**PURCHASING SECTION**  
13450 – 104 Avenue, Surrey BC V3T 1V8  
Tel: 604-590-7274  
E-mail: [purchasing@surrey.ca](mailto:purchasing@surrey.ca)  
**ADDENDUM #1**

<b>REQUEST FOR QUOTATIONS (RFQ) NO.:</b>	<b>1220-040-2017-131</b>
<b>TITLE:</b>	<b>SUPPLY AND DELIVERY OF PLAYGROUND EQUIPMENT [WALNUT PARK]</b>
<b>ADDENDUM ISSUE DATE:</b>	<b>November 2, 2017</b>
<b>CLOSING DATE:</b>	<b>prefer to receive Quotations on or before: November 17, 2017</b>

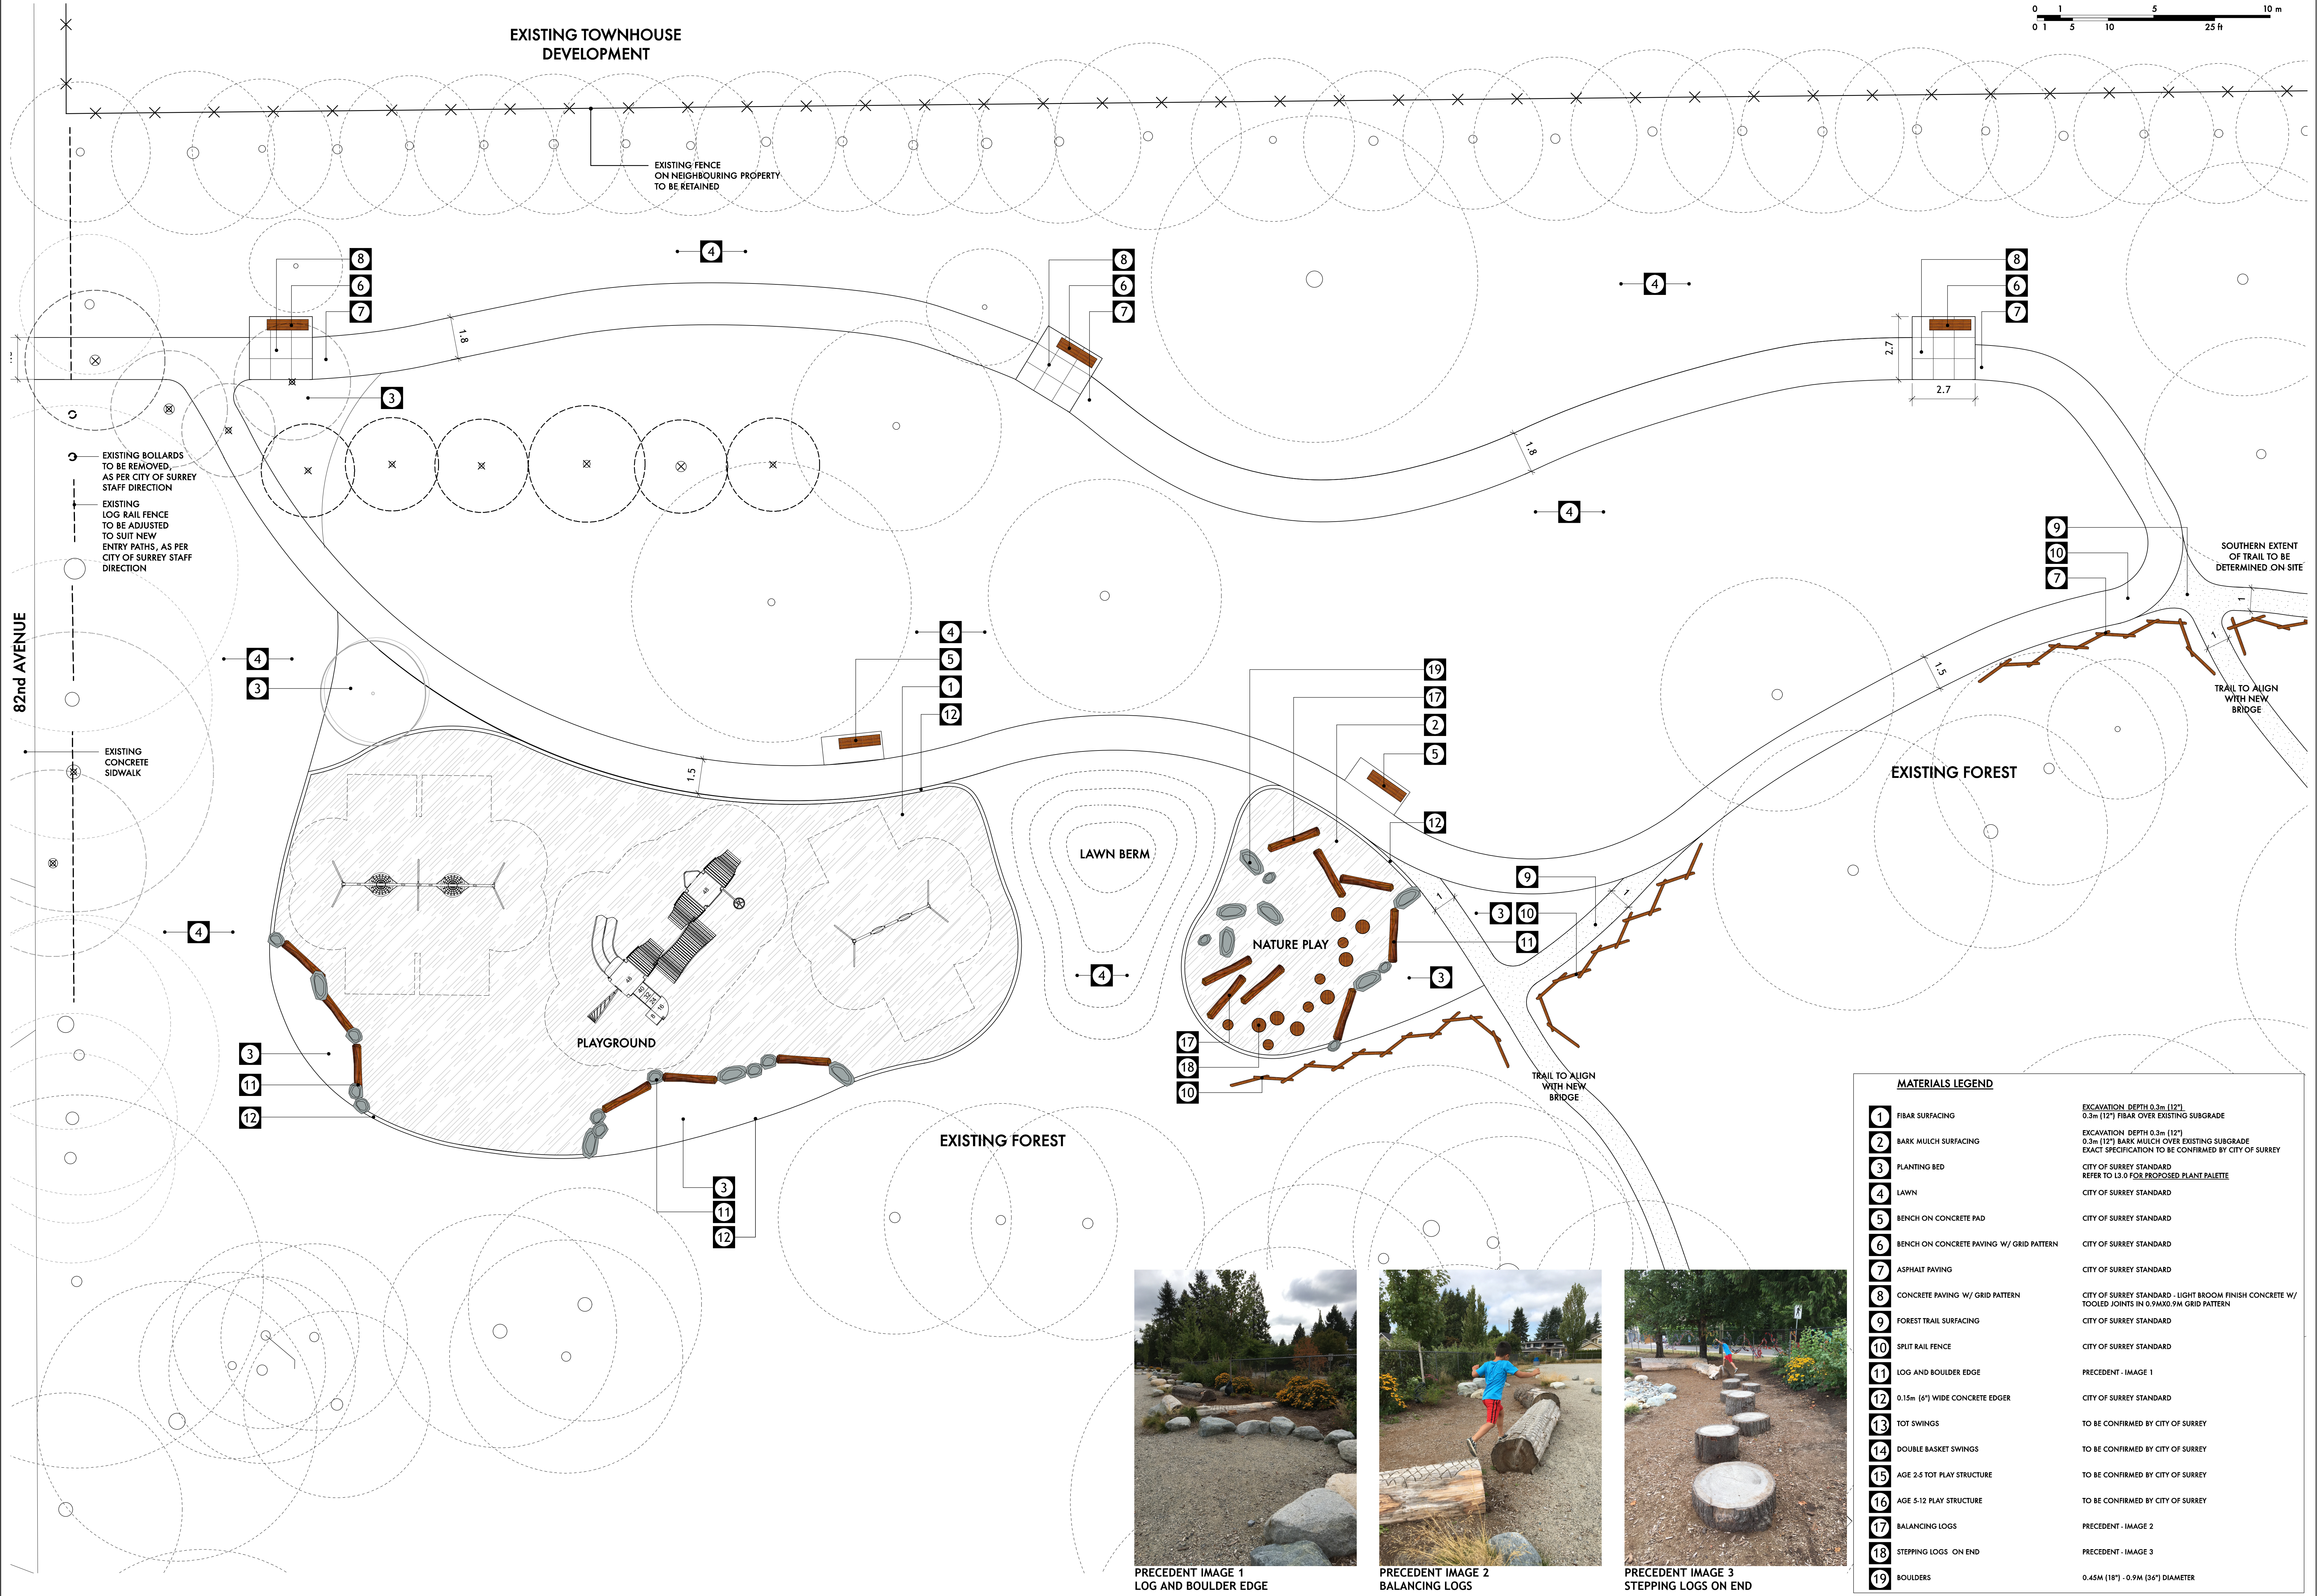
Q2: I was also wondering if you could supply the Concept Plan in a larger format as the legend was unreadable in the document on BC Bid.

Q4: Is the Nature Play area as illustrated on the concept plan separate from the RFQ?

Q5: 2.3 equipment should have a central vertical element mirroring the adjacent forest. Can you clarify what this means?

A2: The Concept Plan in a larger format is attached to this Addendum #1.

A4: Yes.

A5: The location of the playground is adjacent to a forested area, as a part of the concept there was a suggestion that a vertical element (platform above ground) would allow playground users a view into the forest canopy. This vertical element would entice park patrons to look up to the sky and forest when in the park.
